SERVICE BULLETIN

TR-2400

830

SUBJECT: TR-2400 TX NOISE

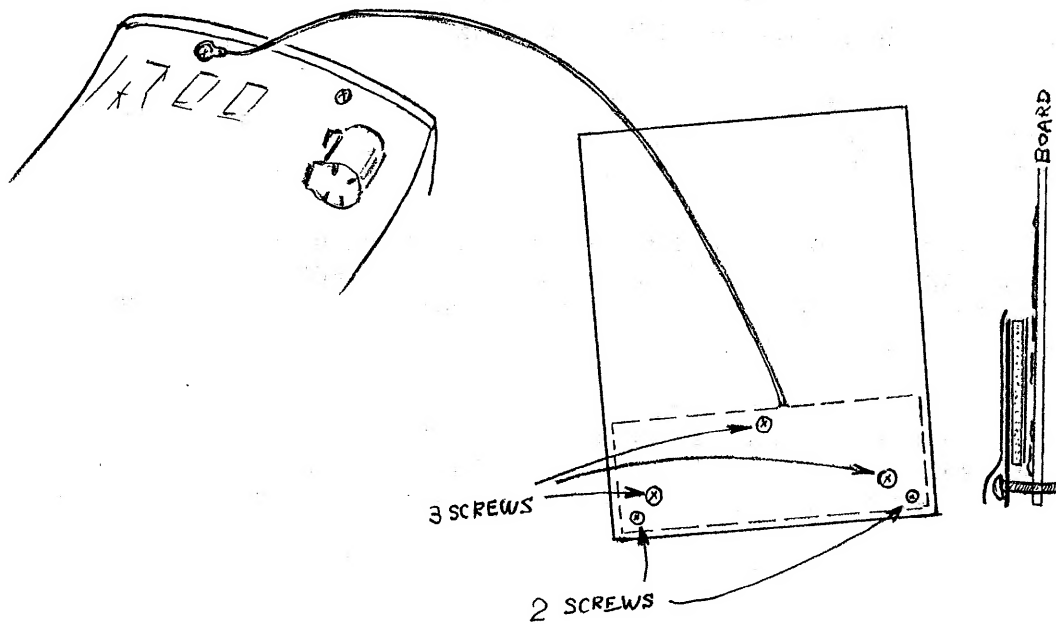
Some units may exhibit excessive background noise (up to several hundred Hertz deviation). This may be reduced or eliminated by installing an additional shield between the Display and PLL units.

This change applies only to units between serial numbers 011xxxx and 101xxxx. Radios before this group (with a momentary REV switch) will not show improvement by addition of this shield. Refer to Service Bulletin 815 for this early group.

1. Remove 4 rear case screws, and 2 screws from inside the battery compartment.
2. Separate front case from body. DON'T tear leads.
3. Remove 2 small and three large screws from the bottom edge of the Display unit. Save the two small screws.
4. Install the three pan head screws in place of the round head screws.
5. Install the shield foam towards the Display. Lift the protective plastic only enough to secure the shield with the two small screws. Cover the screw heads with the plastic film.
6. Secure the shield ground under the small Phillips screw located between the BUSY/OPEN and S TONE switches.
7. When reassembling, the wiring harness must be positioned to the right of crystal X2 (46.1666MHz) or the case will not close correctly, and wires will be pinched.
8. Close the case and reinstall 6 screws.
